Blythe Energy Project Phase II

**Subject: Caithness Blythe II Responses to the Blythe Energy
Phase II Preliminary Staff Assessment**

BLYTHER ENERGY PROJECT
Phase II
(02-AFC-01)

Responses
to
California Energy Commission
Preliminary Staff Assessment

Figure 2
Location of Nearest Residence

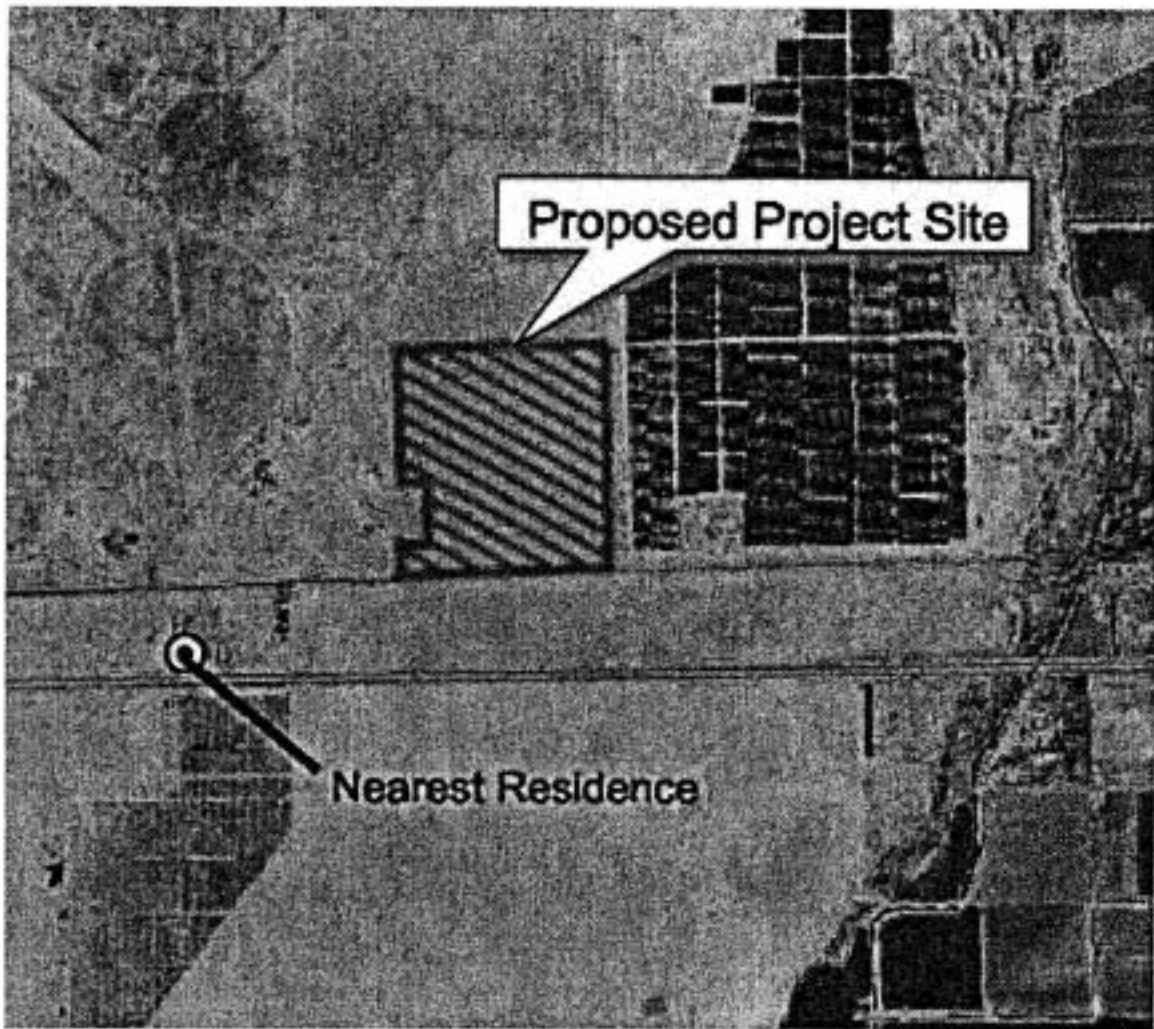
Predicted noise levels are based on a distance of 2728 feet from the sensitive receptor to the BEP II facility and 4798 feet to the Blythe I facility. These are the same values provided in the Section 7.3 of the BEP II AFC (July 2002). A drawing showing the location of the sensitive receptor with respect to the BEP II and BEP facilities is provided as Figure 2 and a drawing of the BEP II and BEP general arrangement is provided as Figure 3.

Figure 4-1
Water Balance at 59F
Blythe Energy Phase II

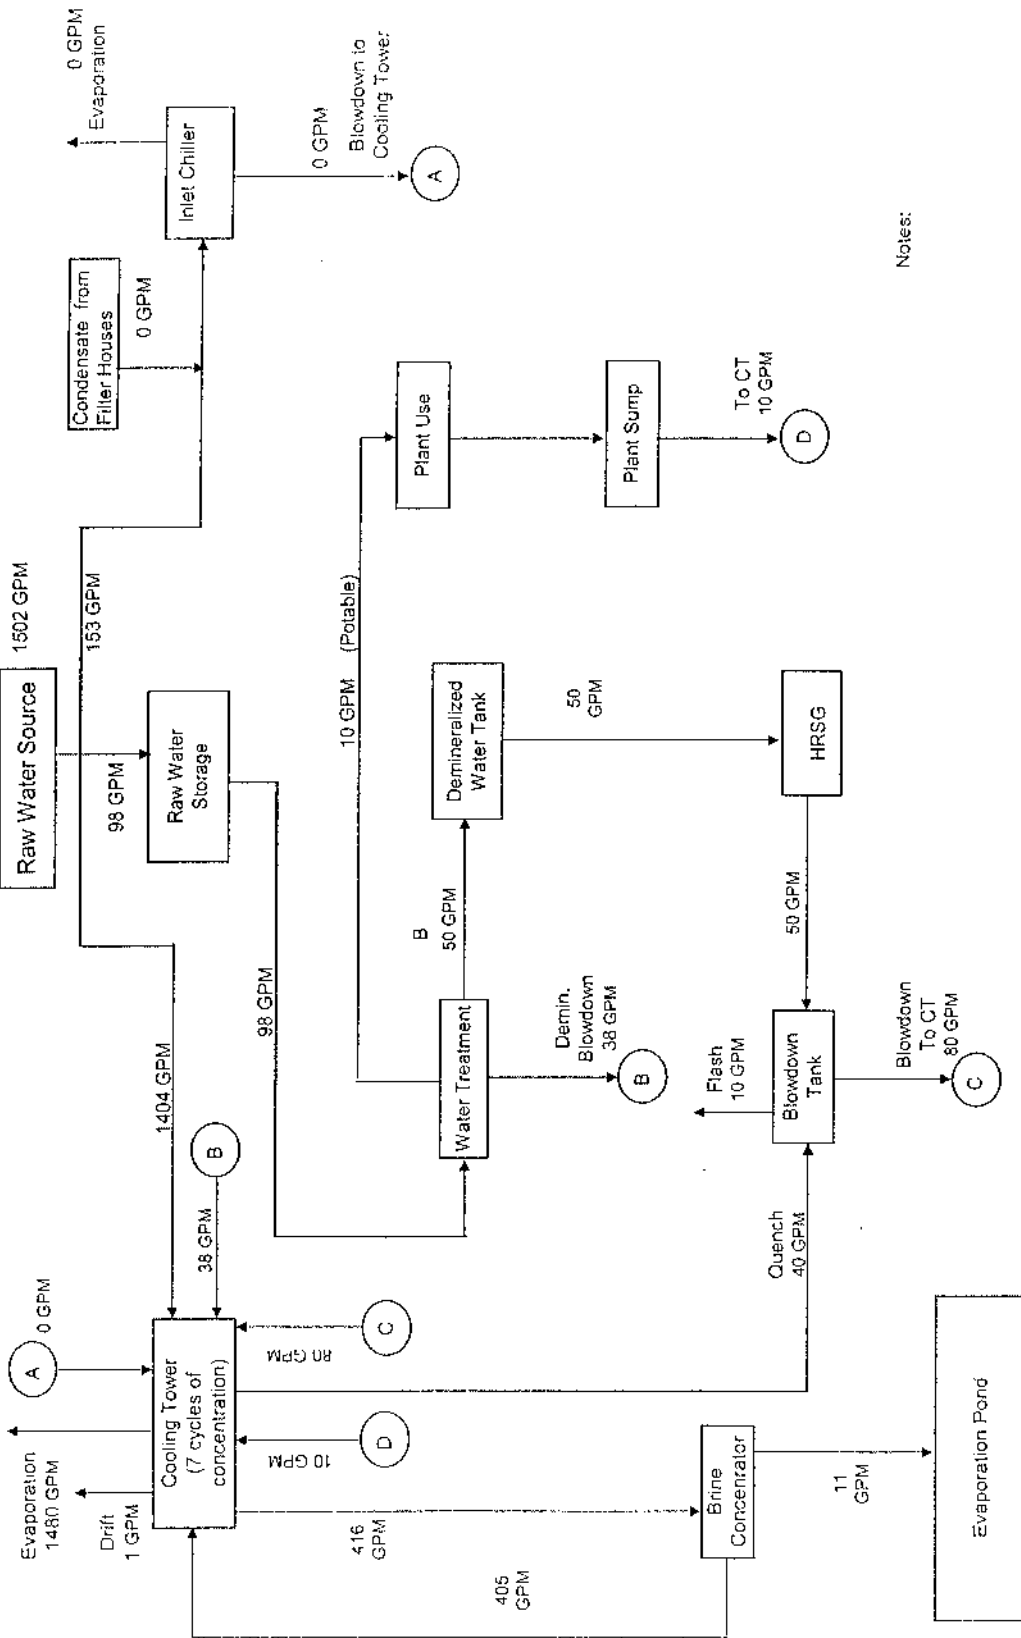
5	<p>The section headed "Water Balances" contains a discussion by Staff on the water balance diagrams provided as part of the water balances provided in the AFC.</p> <p>Staff correctly notes the water balance of Figure 7.13-10A depicts a plant design with evaporative cooling (and CB II agrees that this does not reflect current plant design alternatives).</p> <p>Staff points out the response to DR 144 indicates somewhat more cooling water is required for a plant with a mechanical chiller (in comparison to a plant with evaporative cooling). Staff (and the DR 144 response) are correct in stating that a plant with a mechanical chiller will require more cooling water. This discussion above also applies to Staff's comments on AFC Figure 7.13-10B.</p>	4.9-24
